SERVICE BULLETIN BOOK

SCHWING SERVICE DEPARTMENT

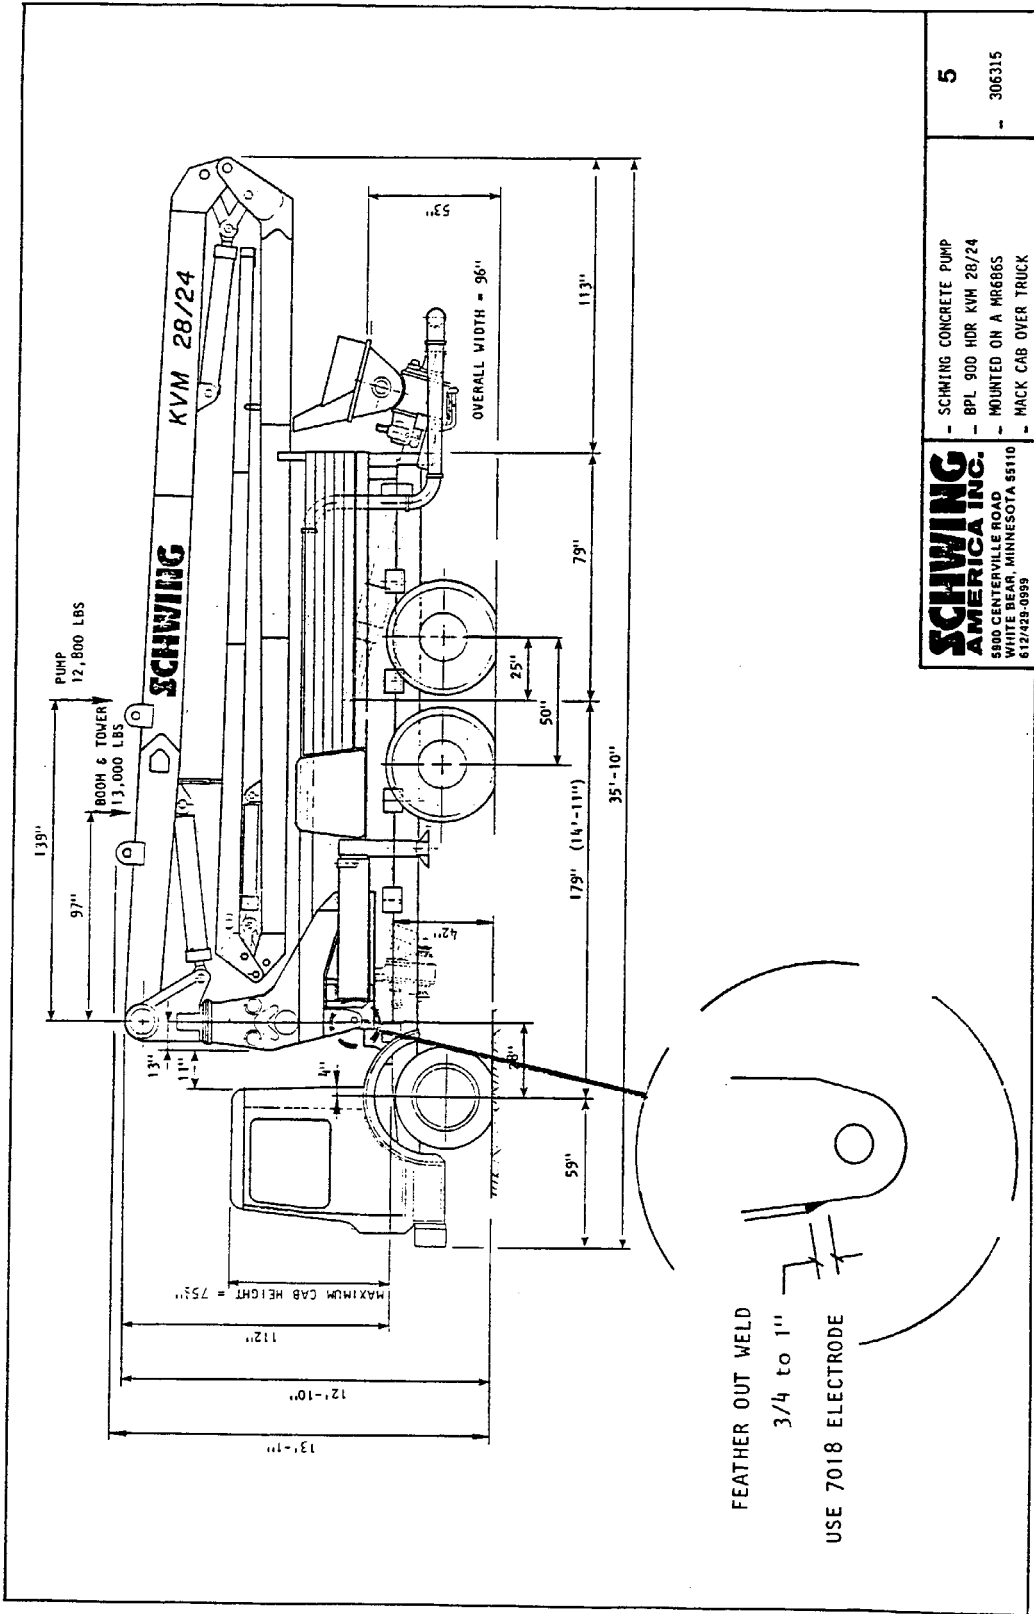
Attached is drawing 306315 for the 900 KVM 28/24 illustrating a location on the tower requiring additional welding. It is very important the area have additional welding as soon as possible because of the possibility that if the unit has insufficient weld, a crack could occur breaking the tower mounting pin ear.

1. Remove all paint and primer in the area requiring welding.
2. Use 7018 electrode.
3. Use D.C. reverse polarity welder.
4. Preheat weld area to 70 to 90°F if ambient or material is below 70°.
5. Use 3/16 max stringer passes. Weld vertically up not vertically down.
6. Grind between each pass.
7. Use a 400°F temp stik applied 1" away from the weld. Temperature must not exceed 400°F.

316190

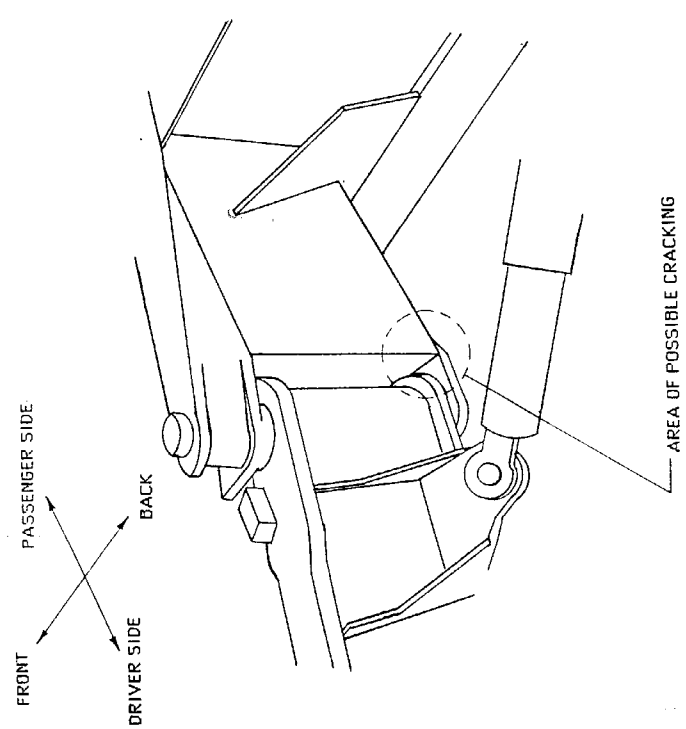
Please inspect your KVM 28 outriggers as soon as possible according to drawing 316190, attached. If the area shown has a crack, grind out and re-weld with E7018 Electrode per SAI Technical Information Sheet 1004, attached, and then call our Spare Parts Department to order reinforcements as follows for each unit that has cracks.

- PROCEDURE:
1. THOROUGHLY CLEAN WITH PRESSURIZED STEAM OR SOLVENT TO REMOVE ALL GREASE AND DIRT.
 2. USE A LIGHT AND MAGNIFIER TO VIEW THE 'AREA OF POSSIBLE CRACKING.' IF ANY QUESTION OF A CRACK USE DIE PENETRANT WHICH CAN BE OBTAINED FROM YOUR LOCAL WELDING SUPPLY HOUSE.
 3. IF THE AREA SHOWN HAS A CRACK, GRIND OUT AND REWELD WITH E7018 ELECTRODE PER SAI TECHNICAL INFORMATION SHEET 1001 ATTACHED.
 4. FOR UNITS WITH CRACKS, CALL SCHWING SPARE PARTS TO ORDER REINFORCEMENTS AND GUSSETS LISTED ON SERVICE BULLETIN NO. G 106-89.
 5. INSTALL REINFORCEMENTS PER DRAWING 316140 ON UNITS WHICH HAD CRACKS.

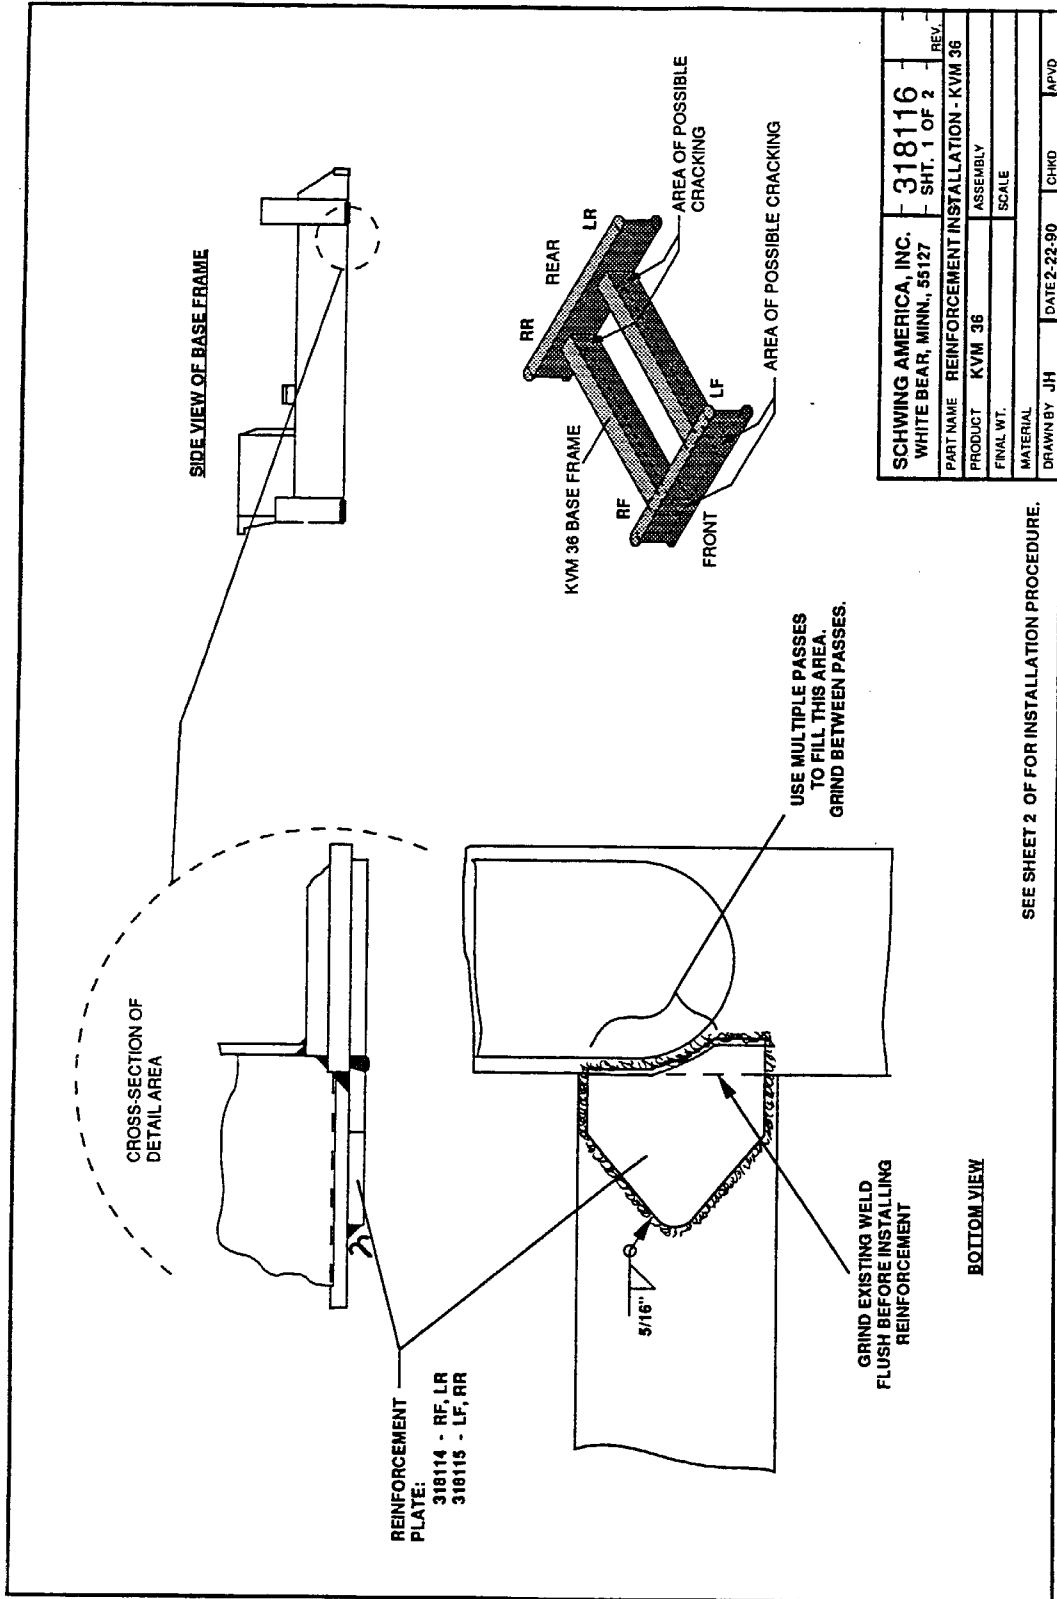
Please inspect the tower of your KVM 36 as soon as possible according to the KVM 36 TOWER SUPPORT INSPECTION PROCEDURE sheet attached. Advise Terry Atherton or Jim Howard of any cracks found and re-weld per instructions on the procedure sheet and Technical Information sheet 1004, also attached.

Install per drawing 318116, attached. These parts will be shipped to you at no charge via regular UPS. Thank you for your prompt attention to this matter. If you have any questions please call Jim Howard or Terry Atherton, Schwing Engineering Department.

1. IF CRACKS ARE FOUND IN THE AREAS OF POSSIBLE CRACKING SHOWN, INSTALL THE REINFORCEMENT PLATE ON EACH CORNER THAT IS CRACKED. (NO REINFORCEMENT IS REQUIRED IF NOT CRACKED)
2. REMOVE OR MOVE ITEMS ON THE TRUCK THAT INTERFERE WITH INSTALLATION SUCH AS HYDRAULIC TUBES, HOSES, ETC.
3. IF NOT ALREADY DONE, GRIND OUT CRACK AND RE-WELD PER SAI TECHNICAL INFORMATION SHEET TI-1004 USING E11018 ELECTRODE. PREHEAT TO 212°F.
4. GRIND WELD SEAM SHOWN FLUSH TO PROVIDE A SMOOTH, FLAT SURFACE FOR THE REINFORCEMENT PLATE.
5. POSITION PLATE WITH BEVELED EDGE OUT TO PROVIDE FOR A GOOD VEE WELD. PLATE SHOULD TOUCH EXISTING FILLET WELD.
6. WELD AS SHOWN. 5/16" ALL AROUND USING E11018 ELECTRODE PER SAI TI-1004. PREHEAT TO 212°F.
7. REPEAT FOR OTHER CORNERS WITH CRACKS.
8. PRIMER AND REPAINT AFFECTED AREAS.

FIGURE 1

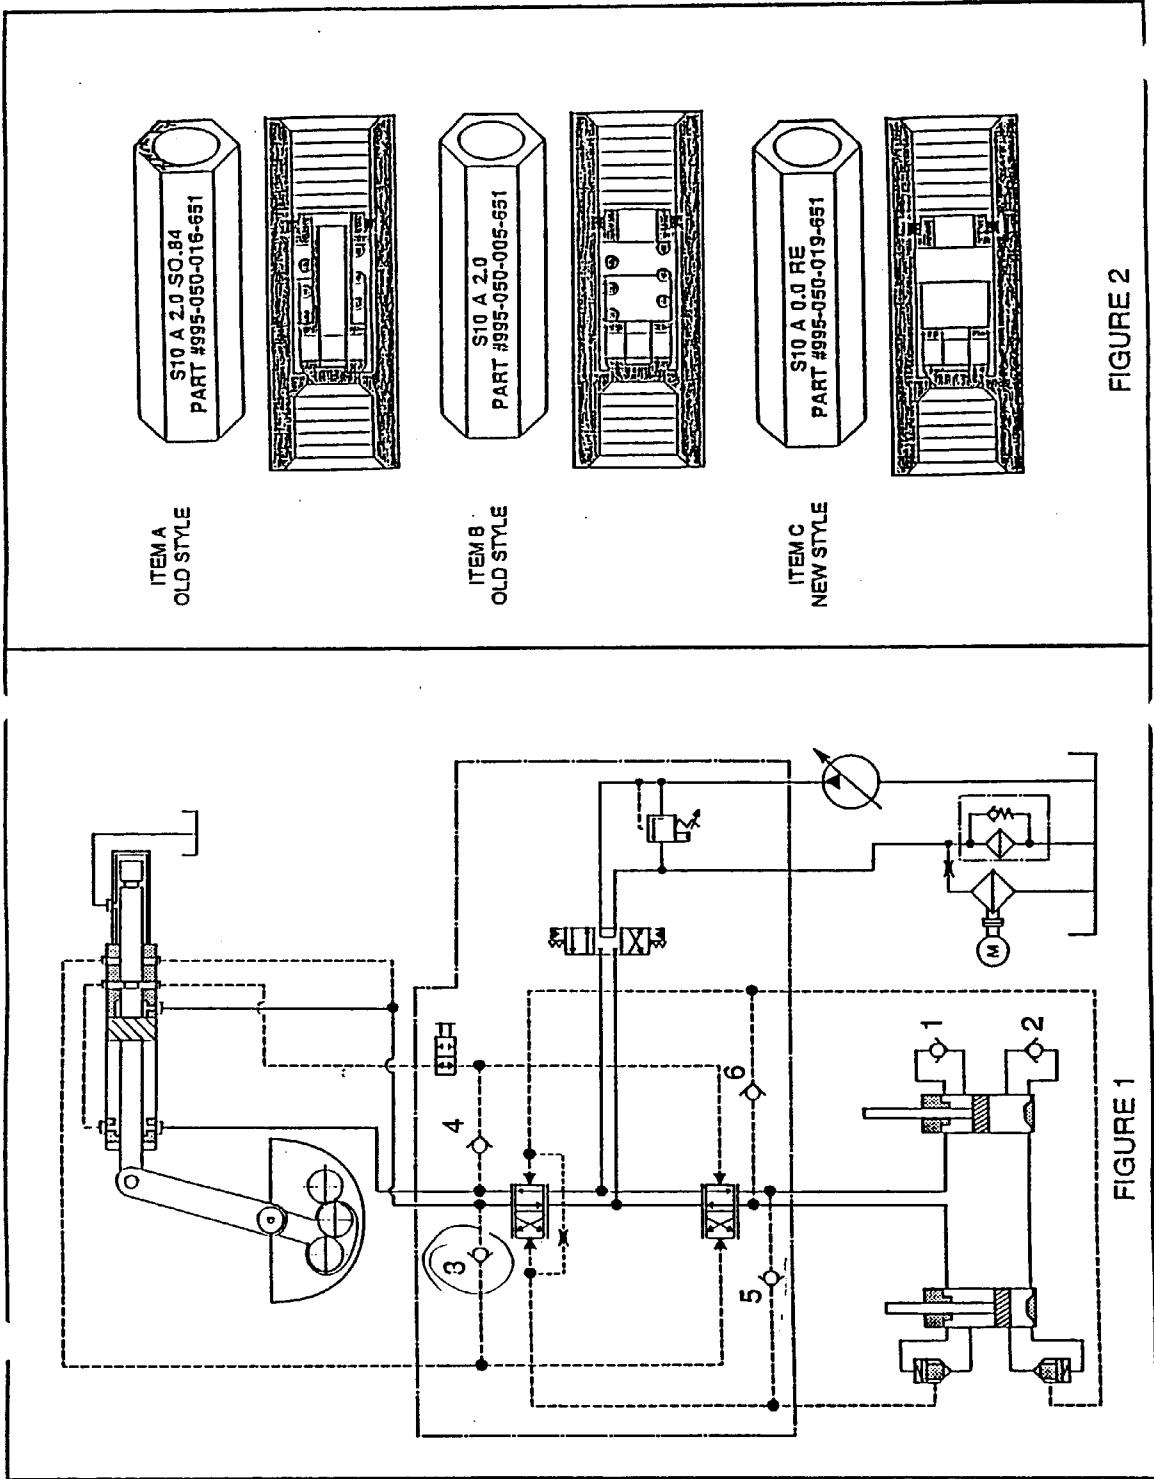
A new style check valve, that has no spring or sleeve, has been made available to replace the check valve that incorporate springs and sleeves. Only BP3000/3001/5000/8000 and BPL 900/1200 rock valve units are involved. Refer to figure 2, item C, for a drawing and part number of the new style check valve.

Use figure 2 as a guide to identify all check valves prior to replacement. Valve C is replacing items A & B. Replace check valves in position 1 through 6 only (refer to figure 1). Make sure the direction of the check valve is not reversed during replacement (refer to figure 1.)

FIGURE 2
995 040 004 700

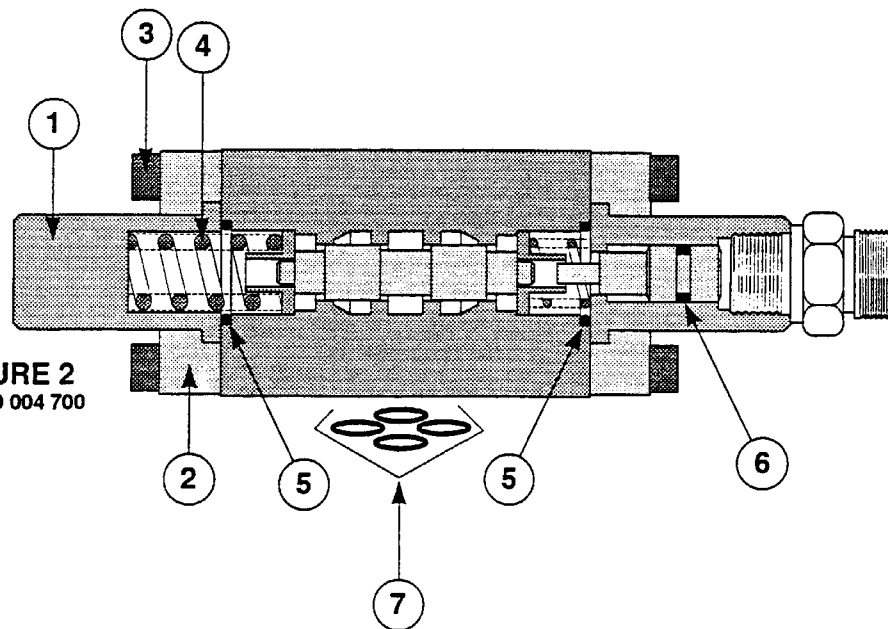
In the past, reversing valve part number 995.040.001.700 (see figure 1) has been used. In the future, all fast switch circuits will be equipped with reversing valve part number 995.040.004.700 (see figure 2). It is recommended that you convert your valve from the style shown in figure 1 to the style shown in figure 2, by ordering the conversion kit. The kit number is 324616 and consists of the following parts:

Use figure 2 as a guide to install the parts on your reversing valve. If you find you have to remove the reversing valve to make the modification, we would advise ordering QTY 4 of position 7, 994.300.290.600, o-ring 8.73 x 1.78 to install between the reversing valve and the baseplate before re-installing.

Figure 1. Shut-off valve locations

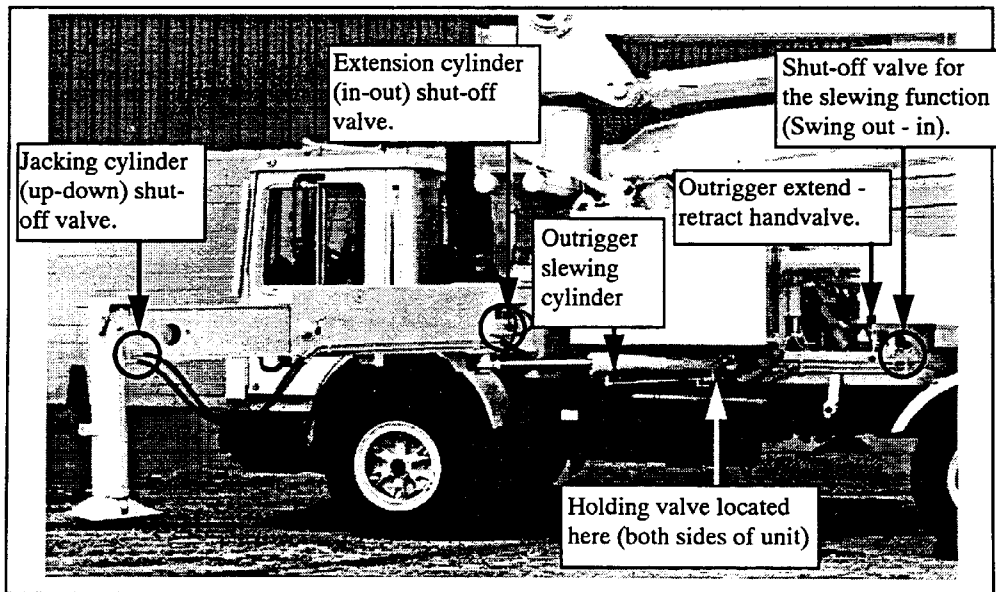
5. Choose one side of the unit to test. AT THIS POINT, BE SURE THAT THE OUTRIGGER IS FREE TO MOVE UP OR DOWN AND SLEW IN OR OUT WITHOUT HITTING ANYTHING. See Figure 1. Open the shut-off valve for the jacking (up-down) function (this is the shut-off valve that is located at the end of the outrigger, above the pad).

6. Be sure that the shut-off valve for the slewing function is closed.
7. Put the outrigger handvalve into the RETRACT position, and bring the pads slightly off the ground. See Figure 2. If the outrigger slewing cylinder begins to retract, even with the shut-off valve closed, you have the problem and you can skip to step 10. If the slewing cylinder did not retract, center the outrigger handvalve, and close the shut-off valve for the jacking function. The pad should still be slightly off the ground.

Figure 3. Comparison of the old and new style holding valves

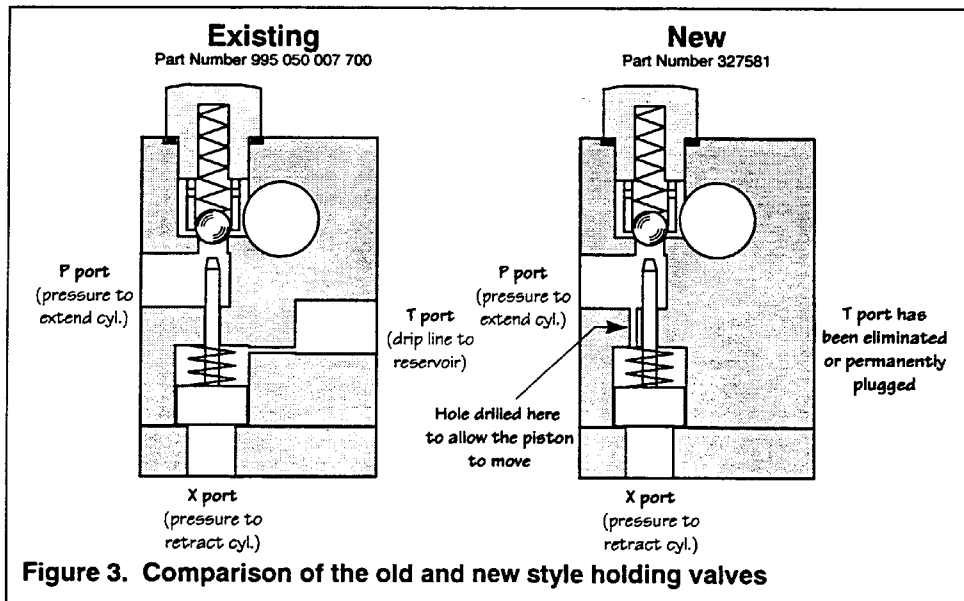
- a. Qty 2 of Part Number 327581, holding valve *See Figure 3.* Note that some new style holding valves don't have a drip line at all, while others will have a plug installed with permanent loc-tite. If the drip line is plugged, do NOT remove the plug.
- b. Qty 4 of Part Number 997 285 192 852, 22 x 27 copper seal ring (for the new holding valve stems)
- c. Qty 1 of Part Number 994 180 108 000, M12 L capnut
- d. Qty 1 of Part Number 994 183 608 000, VS 12 L/S dead plug
- e. Qty 1 of warranty claim

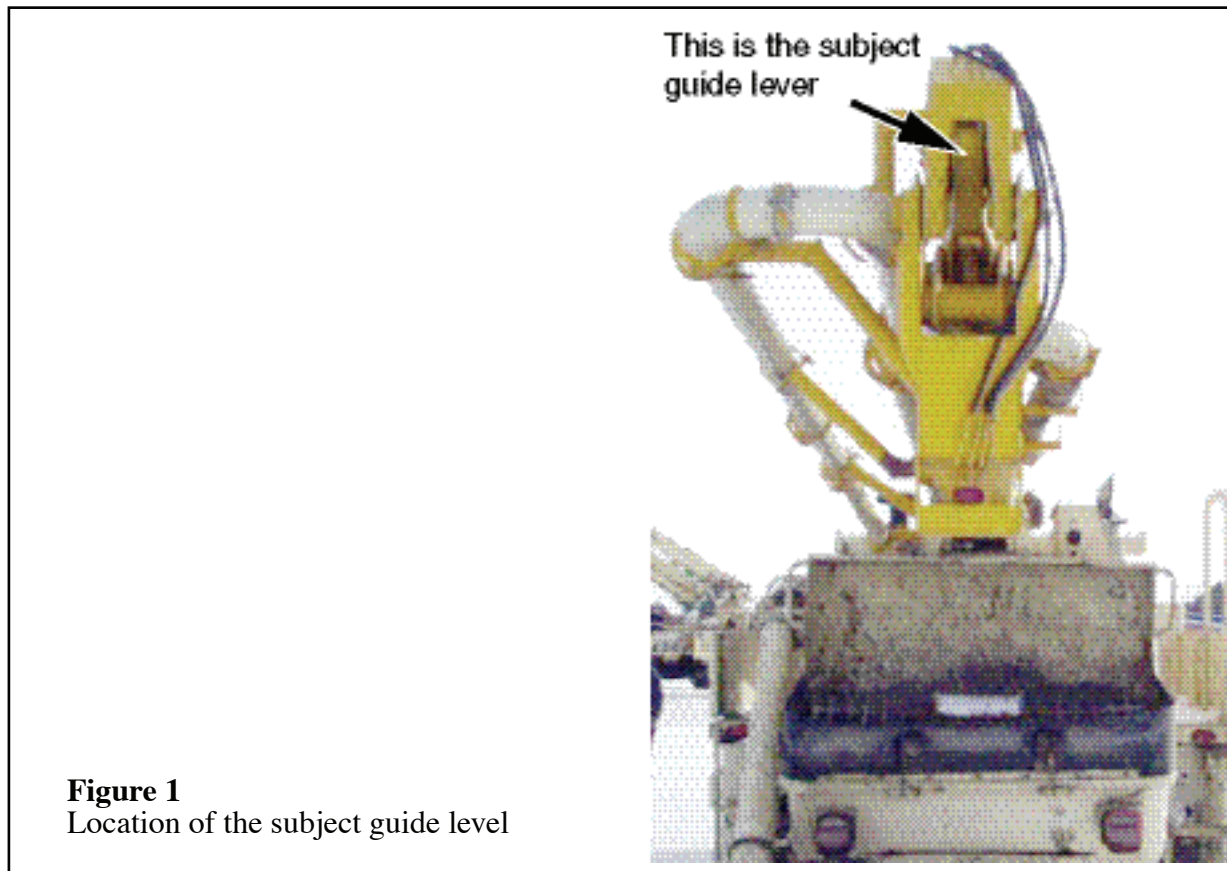
Figure 1 shows the location of guide lever covered by this bulletin. To see both sides of the guide lever, you may have to unfold the boom. As always, outriggers must be set before unfolding.

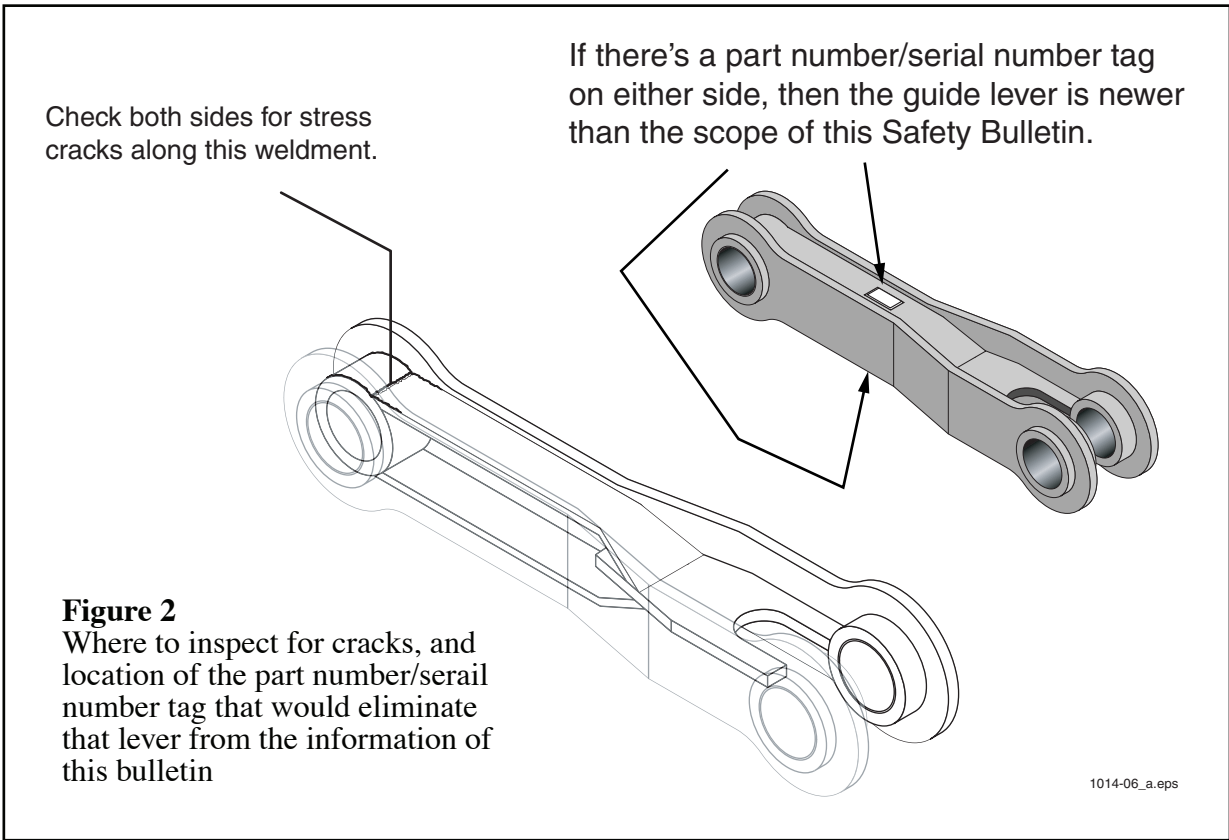
Figure 2 is a detail view of the guide lever, showing the area of possible cracking. Please note: If the guide lever on your machine has a part number/serial number tag on either side as shown, then that guide lever is NOT subject to the information contained in this bulletin, because it is newer than the units in question. We have made kits that include the parts necessary to exchange the old guide lever with the new one. See Figure 3. Each kit contains:
